Independent Review of Flood Modelling

Narromine to Narrabri Inland Rail Project

Holding Redlich
1283-03-B [DRAFT], 19 February 2021

Figure 4.1 - Change in peak flood level at Tomingley Road crossing to the south of Narromine

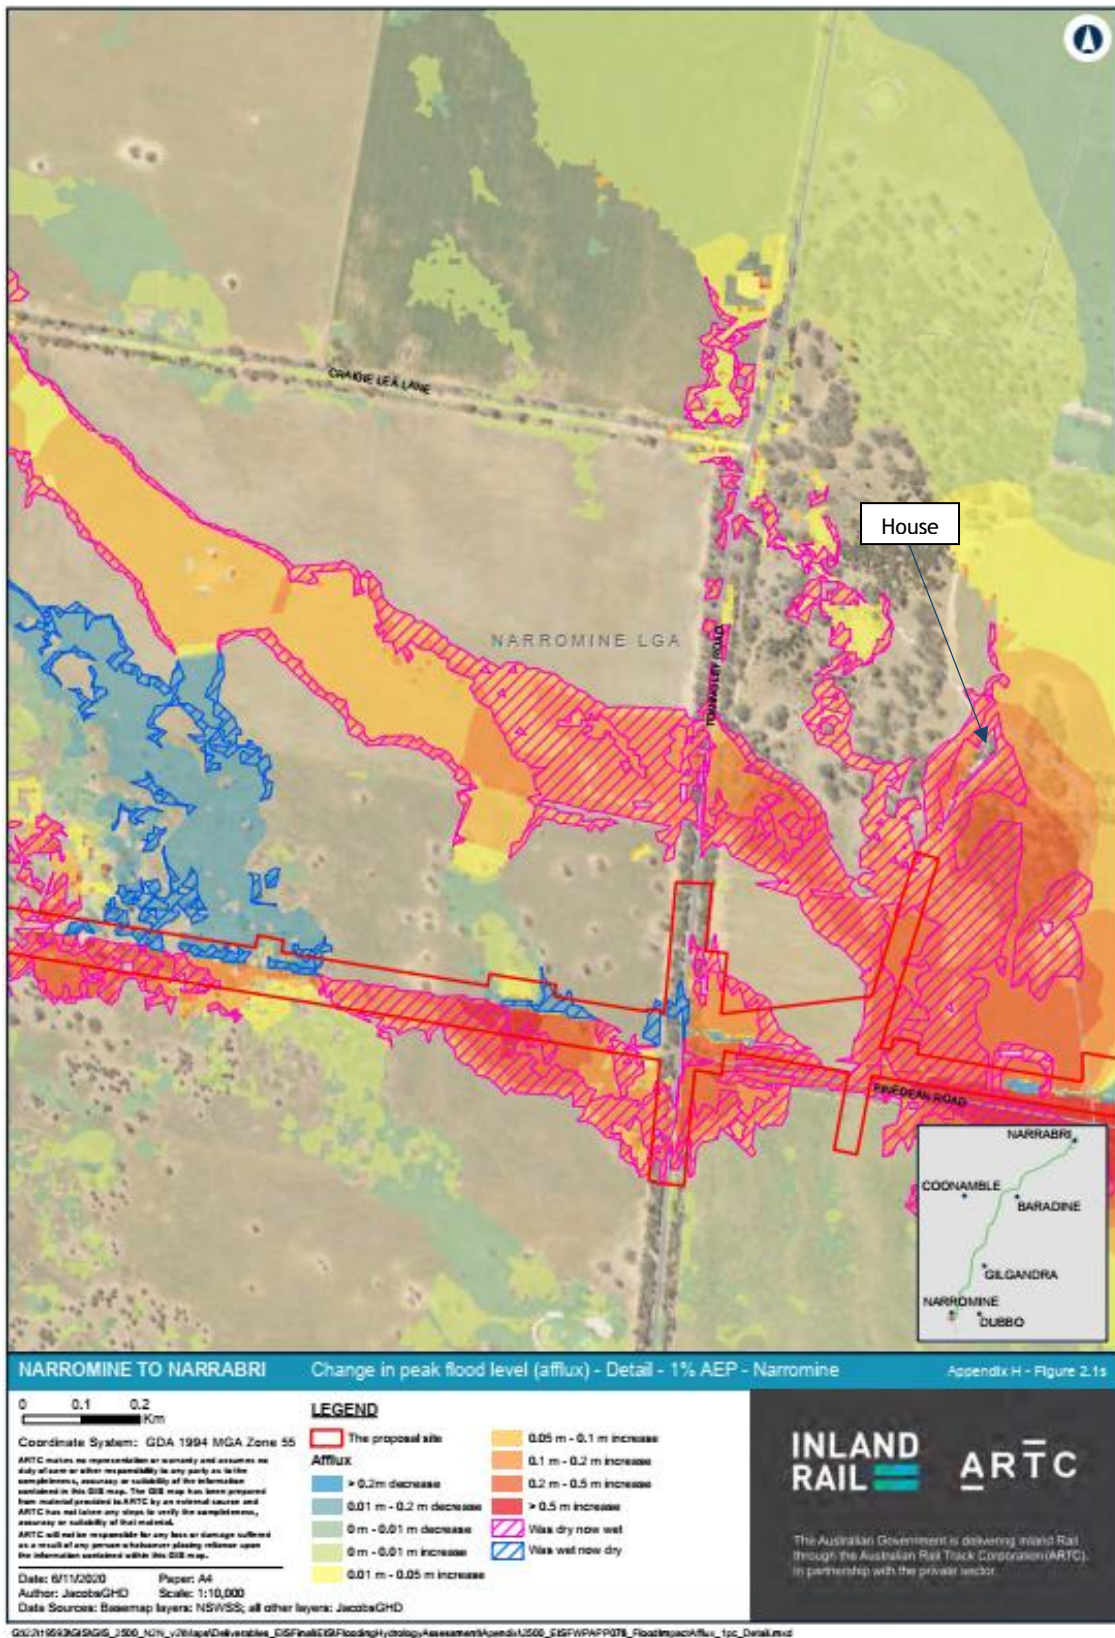
- to the south of Webb's Siding along Wallaby Creek and its tributaries (see Figure 4.1);
- to the south of the Castlereagh River to Nancarrow Road (N2N11N12 flood model);
- along the Gulargambone Creek tributaries (N2N10 flood model); and
- along Box Ridge Road to the north of Baronne Creek (N2N9 model).

The impact of these changes will vary at each individual property as it depends on the site infrastructure such as fences and whether the individual paddocks are cropped. Figure 4.1 shows a high resolution image of the changes in flow patterns that are predicted to the west of Wallaby Creek along Tomingley Road (to the south of Narromine). This figure was extracted from Appendix F of Technical Report 3. The figure shows that the changed flows would increase frequency and depth of flooding at a house and shed as well as along boundary fences. It is not possible to show the impacts at other locations because of the quality of the flood mapping, as described above.

Overall, it suggests that there are insufficient culvert locations to prevent changes in the distribution in flow at this location, and potentially at many other locations. It is suggested that ARTC engage with each landholder with higher resolution maps to explain the predicted impacts and attempt to address any concerns.
